# CLASS I SERVICE INSTRUCTIONS

No. 1180  
ATA Code 76-10

- SUBJECT:** ENGINE CONTROLS - MODIFICATION OF THE CARBURETOR MIXTURE CONTROL ARM
- EFFECTIVITY:** BEECHCRAFT C23 Sundowner 180, serials M-2144 through M-2260.
- REASON:** To ensure full travel of the carburetor mixture control arm.
- COMPLIANCE:** Beech Aircraft Corporation considers this to be a mandatory modification and it should be accomplished as soon as possible after receipt of these Service Instructions, but no later than the next 100 service hours.
- APPROVAL:** FAA Approved.
- MANPOWER:** The following information is for planning purposes only:

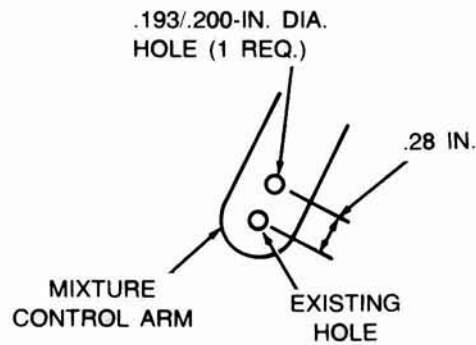
1. Remove the engine cowling.
2. Disconnect the mixture control cable from the carburetor mixture control arm.
3. Drill a .193/.200 inch diameter (No. 10) hole in the mixture control arm as shown in the illustration.
4. Reattach the mixture control cable to the control arm, using the new hole drilled in step 3 and check to

ensure that the arm moves through its full range of travel. Adjust the rod ends and the position of the cable clamp as necessary to permit full travel of the mixture control arm with a slight "cushion" (no more than 1/16 inch) at the forward end of travel.
